PROJECT:
Green Meadow Elementary School -
Early Site Package
5 Tiger Drive
Maynard, MA 01754
Project No.

ADDENDUM NO. 1 06/07/2024

ADDENDUM NO. 1
to the Contract Documents Bid Set dated May 22, 2024

GREEN MEADOW ELEMETARY SCHOOL PROJECT
EARLY SITE BID PACKAGE
Maynard, Massachusetts

C-00

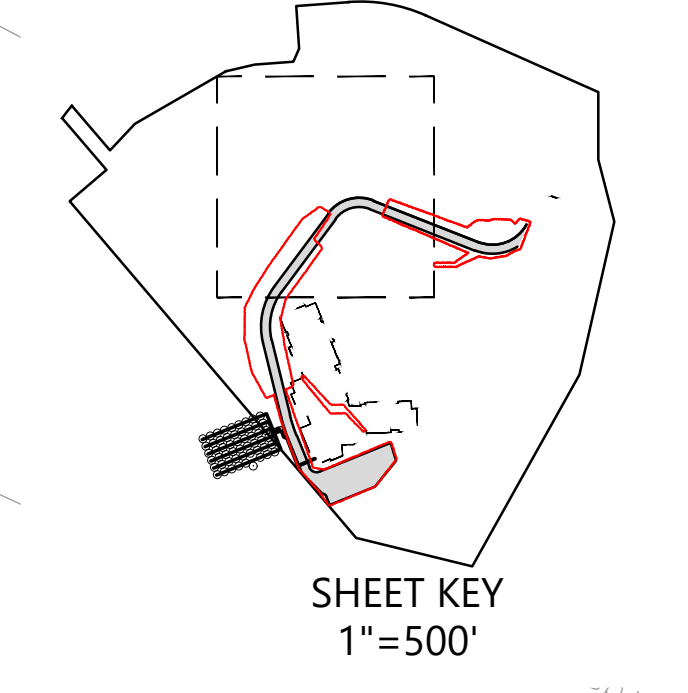
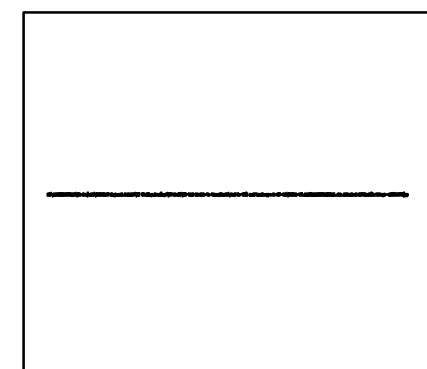
DRAWING C-00 – OVERALL PLAN

ITEM 01: Revised access drive entrance

ITEM 02: Revised retaining wall layout

C-01.2

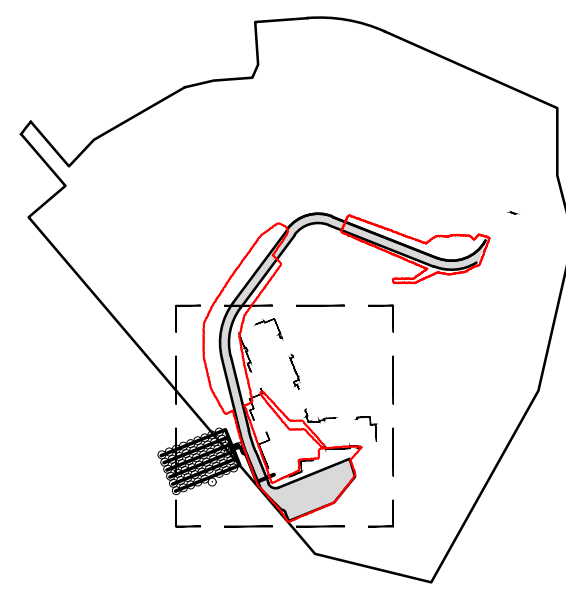
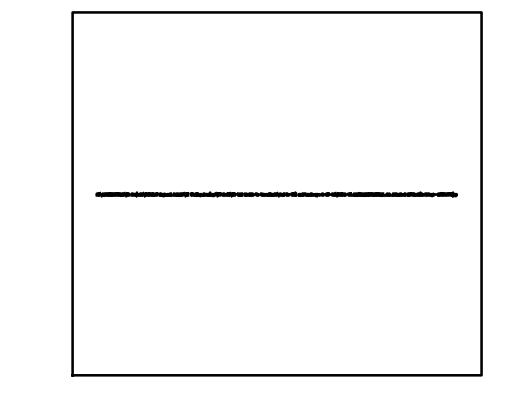
DRAWING C-01.2 – DEMO PLAN

ITEM 01: Revised Limit of work, construction fence and silt sock layout

C-02.1

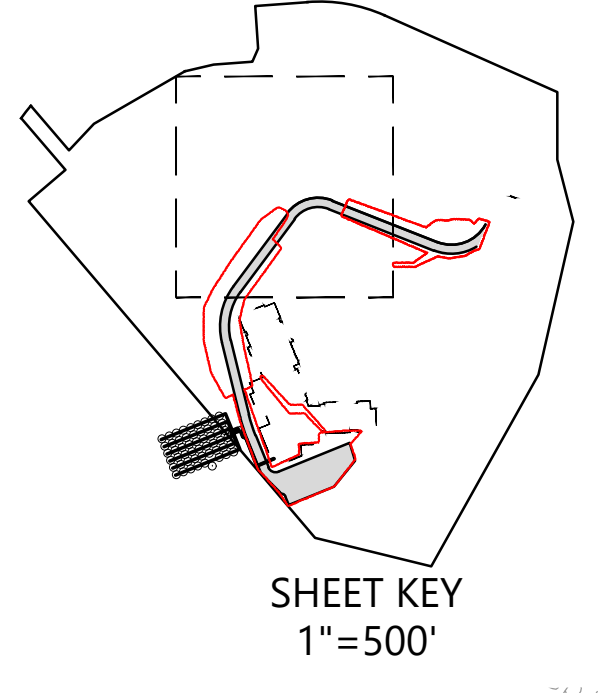
2. Some of the site plans need to show additional grading / contours: a. Please provide contours for the proposed roadway from the well area to the parking area b. Please provide the top and bottom of the proposed retaining walls – only one corner of one wall is shown on the plans. c. Please provide the contours for the final grading of the proposed well field – how do we leave the finished grade? Loam & seeded?

Regarding the tiered retaining walls at the west end of the site, what are the proposed grades between them?

DRAWING C-02.1 – SITE PREPARATION PLAN

ITEM 01: Revised retaining wall layout

ITEM 02: Grades added to retaining wall

ITEM 03: Revised grades at access drive and parking area

ITEM 04: Note added for building pad prep

C-02.2

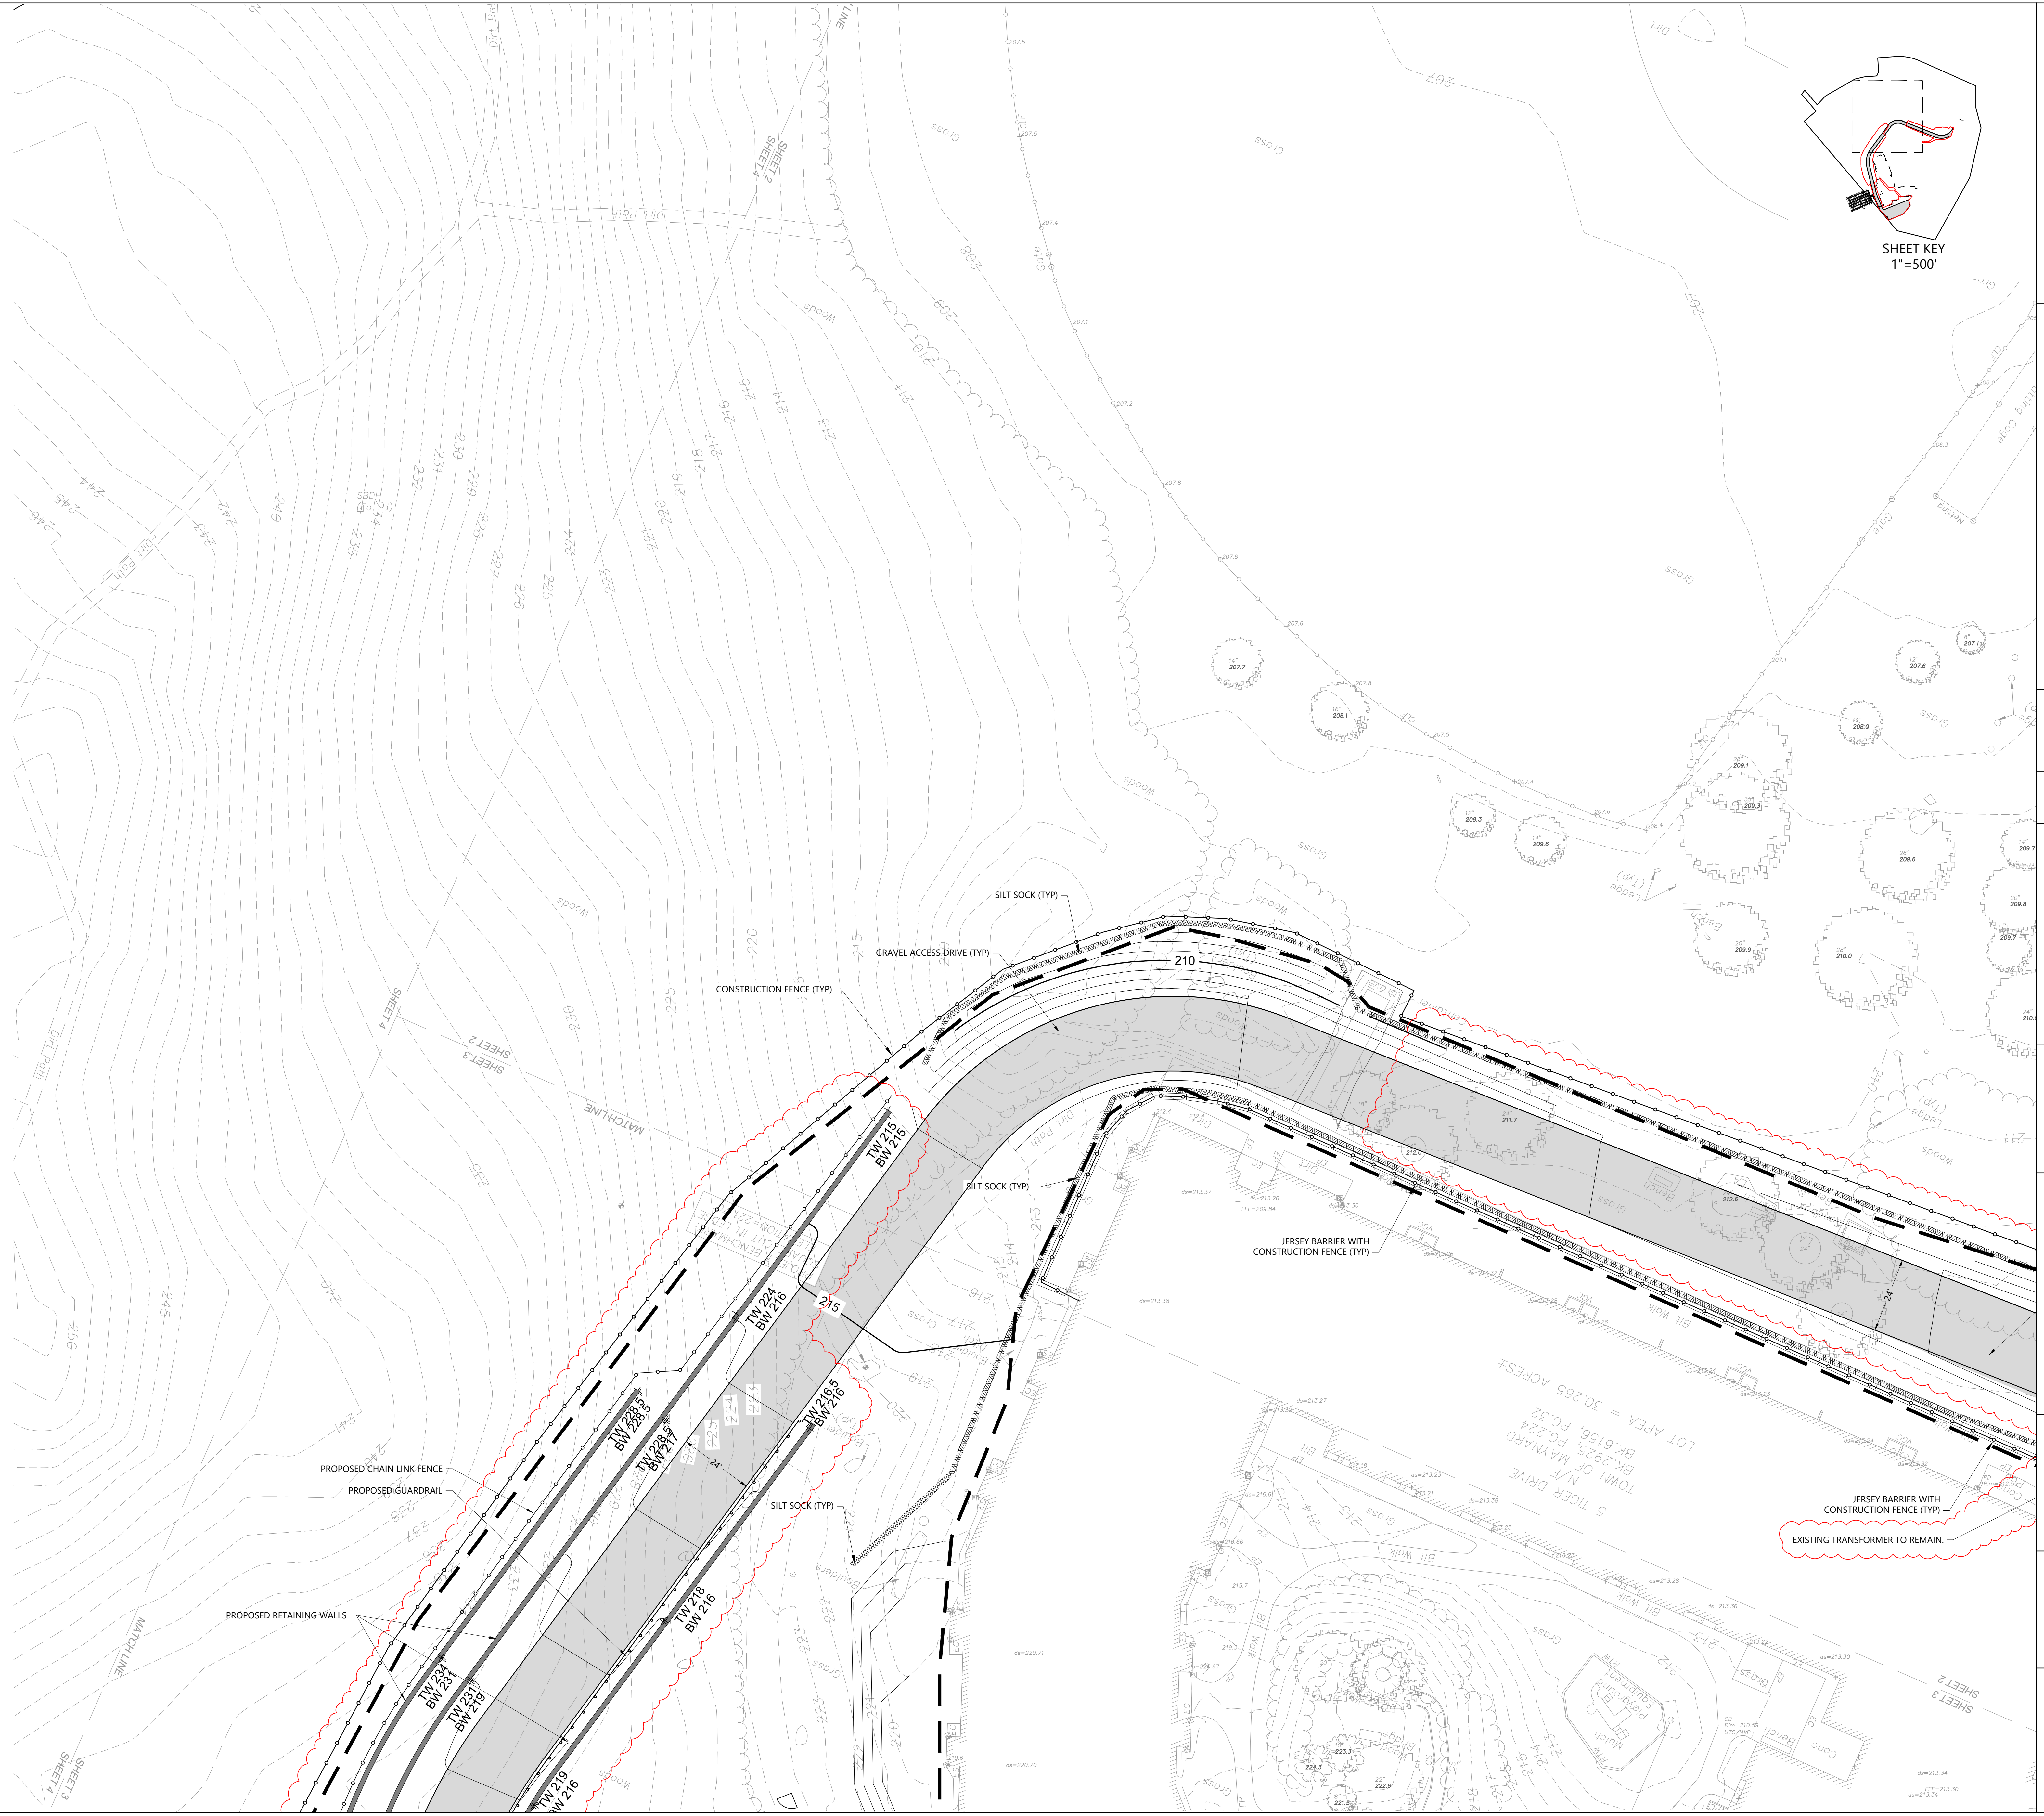
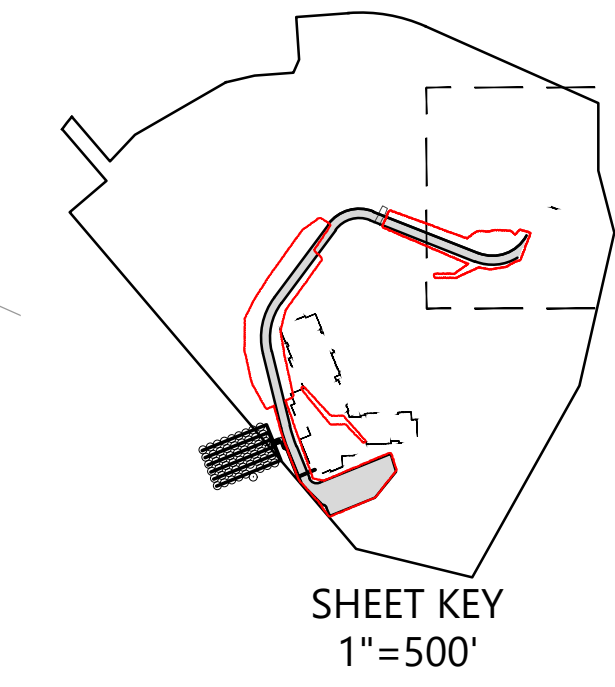
DRAWING C-02.2 – SITE PREPARATION PLAN

ITEM 01: Revised retaining wall layout

ITEM 02: Grades added to retaining wall

ITEM 03: Revised access drive layout

ITEM 04: Revised Limit of work, construction fence and silt sock layout
